## HISTORIC AND DESIGN REVIEW COMMISSION

May 4, 2022

**HDRC CASE NO:** 2022-220  
**ADDRESS:** 618 MUNCEY  
**LEGAL DESCRIPTION:** NCB 1302 BLK 3 LOT 9  
**ZONING:** R-5 H  
**CITY COUNCIL DIST.:** 2  
**HIST. DIST. NAME:** Dignowity Hill  
**APPLICANT:** Marcello Martinez/1718 Architecture  
**OWNER:** Ling Han Martinez/618 Muncey  
**TYPE OF WORK:** Window and door replacement, fenestration modifications  
**APPLICATION RECEIVED:** March 31, 2022  
**60-DAY REVIEW:** Not applicable due to City Council Emergency Orders  
**CASE MANAGER:** Jessica Anderson

A2.01

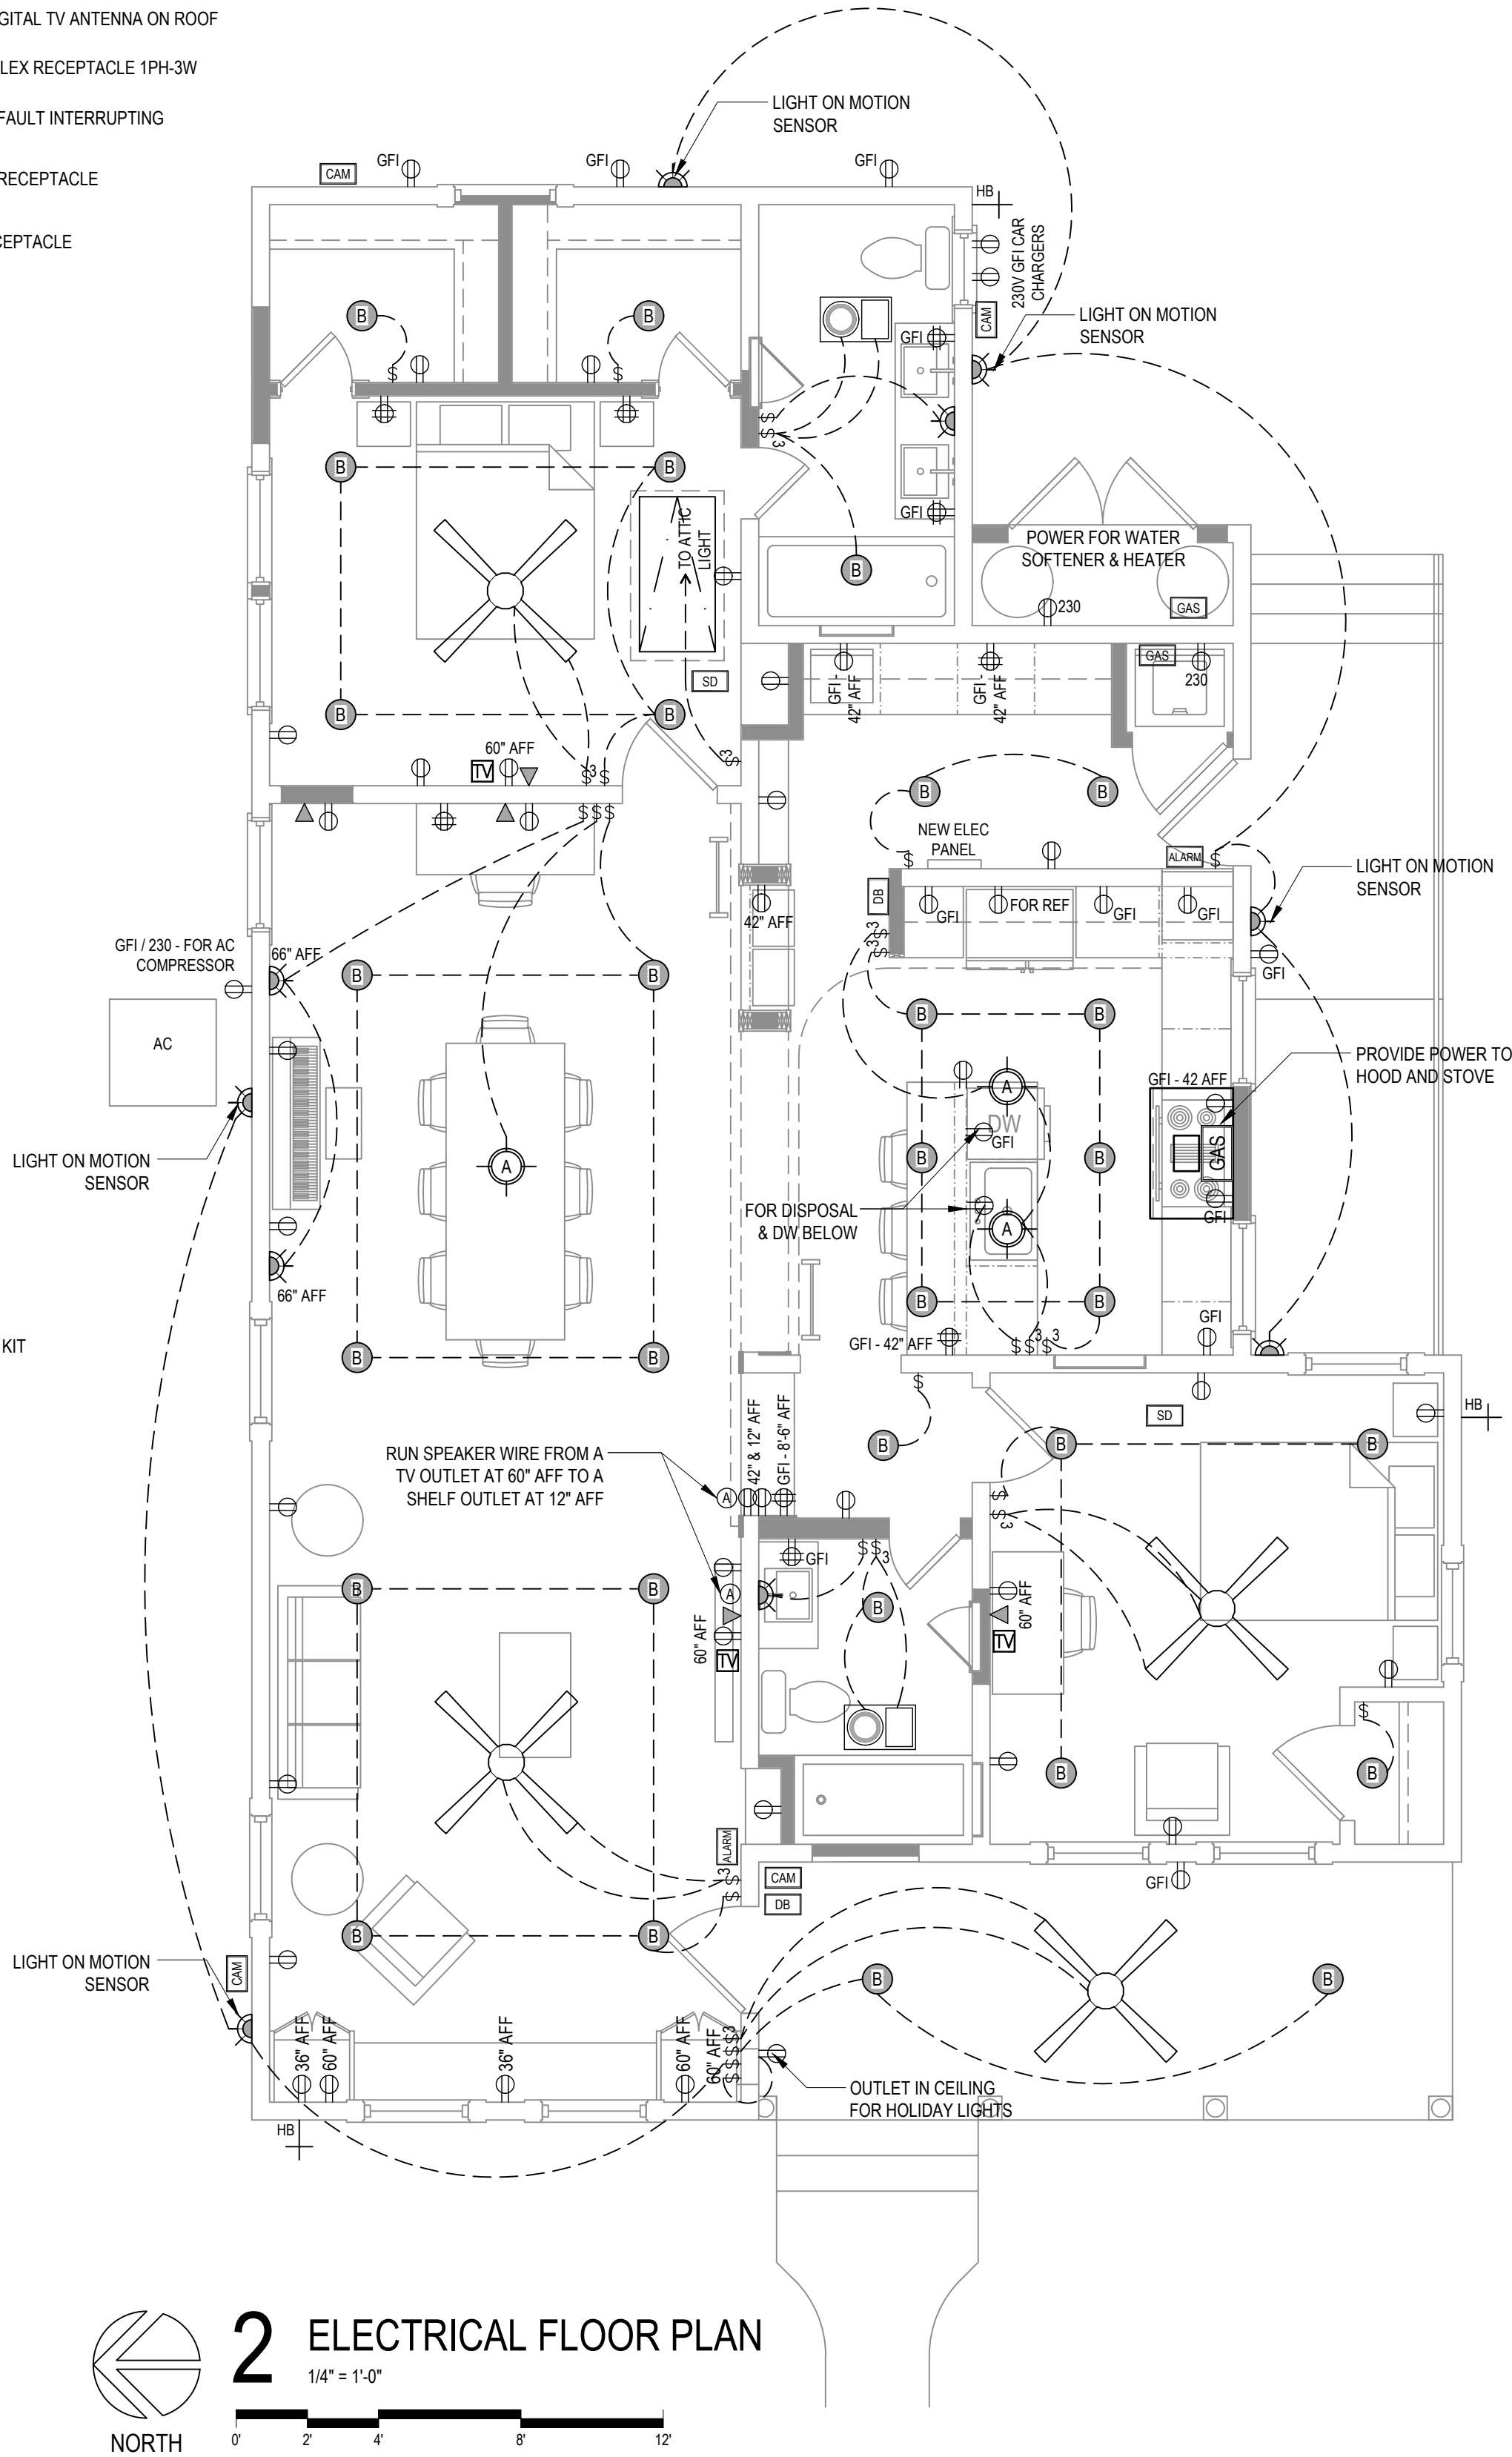
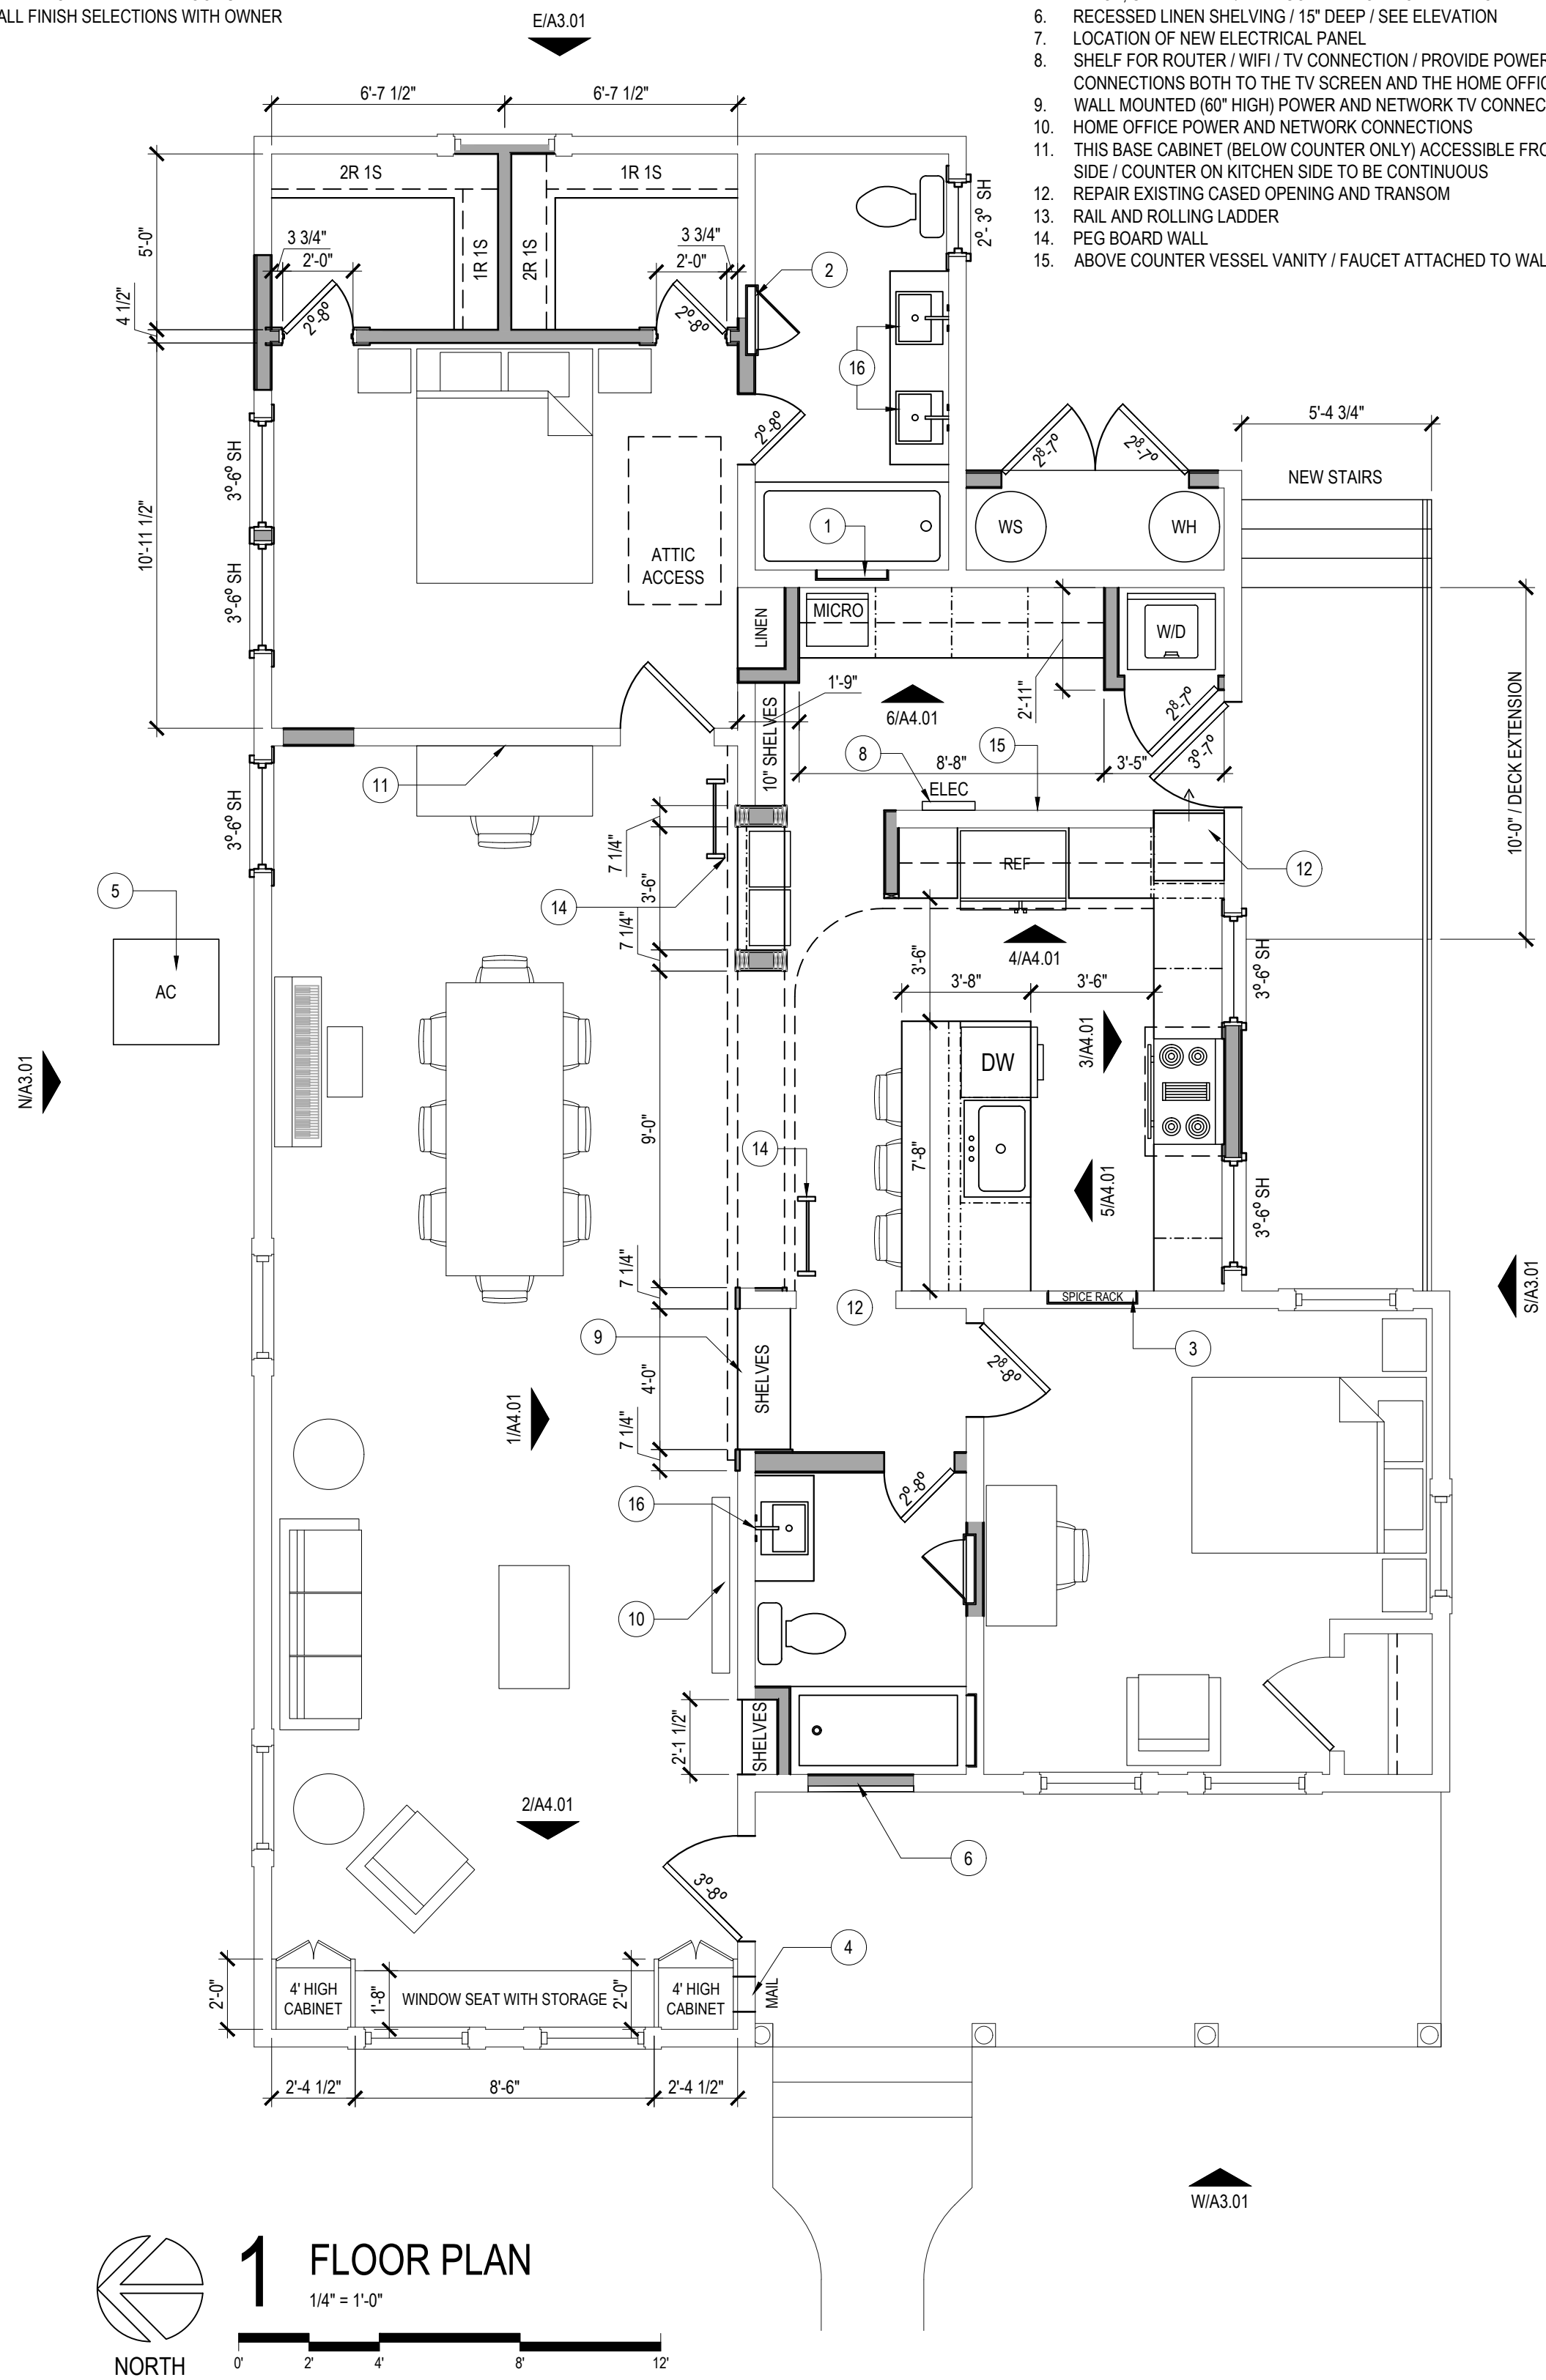
- c. PORCH: Per images submitted by the applicant, the house previously had a door on the north side of the front porch. The applicant proposes returning a door and transom to this location to match the existing door and transom located on the east side of the front porch. Staff finds the proposed door and transom consistent with Historic Design Guidelines for Exterior Maintenance and Alterations 6.A.

- d. FENESTRATION CHANGES: The applicant proposes relocating one exterior door on the south elevation from the central bay to the rear bay and add two new windows to the central bay. Adding the door to the rear bay results in loss of a smaller window on that bay. The applicant also proposes infilling one window on the north elevation and adding a pair of ganged windows and one single window to the north elevation. All proposed windows match existing windows in style and dimensions. The applicant provided photos of both the north and south elevations showing changes to the fenestration pattern over time. Staff finds that proposed fenestration changes as well as proposed new windows and doors are consistent with staff's standards for replacement windows should be installed. Staff finds the proposed door relocation on the south elevation appropriate.

- e. MECHANICAL EQUIPMENT: The applicant proposes relocating the air conditioning unit from the rear of the house to the north side of the house. Historic Design Guidelines for Additions 5.A.ii states that where service areas cannot be located at the rear of the property, compatible screens or buffers will be required. Staff finds the applicant must shield the air conditioning unit with screens or buffers so it is not visible from the right-of-way.

- i. That the head and sill heights of the proposed window openings match the existing. Window widths and profiles are to match as well.

- i. That compatible screens or buffers be utilized to screen the air conditioning unit from view from the right-of-way.
